# Access Compliance Report

## Public Rights-of-Way

### (Curb Ramps)

Intersection ID: 46932	Main Street: IDLEWILD_RD_NORTH	Cross Street: SYCAMORE_GROVE_CT	Location: NE
ADA ID: 3AA458024115	Ramp Type: PerpDiag	Initial Pass/Fail: Fail	Overall Compliance: No
Severity Score: 21.25			
Codes/Mitigation Info/Possible Solution		Field Measurements/Component Compliance

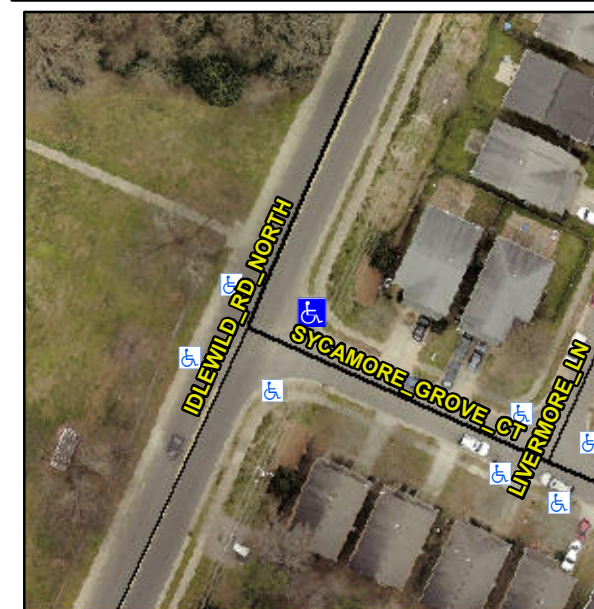
**Not Found, R304.5.1, R304.2.2**

Compliance	Description	Data	Compliance	Description	Data
N/A	Ramp Length (in)	48.0	No	Ramp Slope (%)	9.7
No	Ramp Width (in)	41.0	Yes	Ramp XSlope (%)	0.9
N/A	Flare Type LT	N/A	N/A	Flare Type RT	N/A
N/A	Flare Slope LT (%)	N/A	N/A	Flare Slope RT (%)	N/A
N/A	Flare Traversable LT?	N/A	N/A	Flare Traversable RT?	N/A
N/A	Landing Length (in)	N/A	N/A	DWS Provided?	N/A
N/A	Landing Width (in)	N/A	N/A	DWS Contrast?	N/A
N/A	Landing Slope (%)	N/A	N/A	DWS Length (in)	N/A
N/A	Landing X Slope (%)	N/A	N/A	DWS Full Width?	N/A
N/A	Landing Curb? (Y/N)	N/A	N/A	DWS Offset (in)	N/A
N/A	Shared Landing?	N/A			
N/A	Gutter Ponding?	N/A	N/A	Gutter Slope (%)	N/A
N/A	Gutter Lip Ht (in)	N/A	N/A	Gutter X Slope (%)	N/A
N/A	Painted X Walk1?	No	N/A	Painted X Walk2?	No
	X Walk 1 Direction	To NW		X Walk 2 Direction	To SW
N/A	X Walk 1 Width (in)	N/A	N/A	X Walk 2 Width (in)	N/A
	X Walk 1 Slope (%)	4.2		X Walk 2 Slope (%)	5.0
	X Walk 1 X Slope (%)	1.0		X Walk 2 X Slope (%)	1.8

**Remove & Replace Curb Ramp With Two New Directional Ramps or Equivalent.**
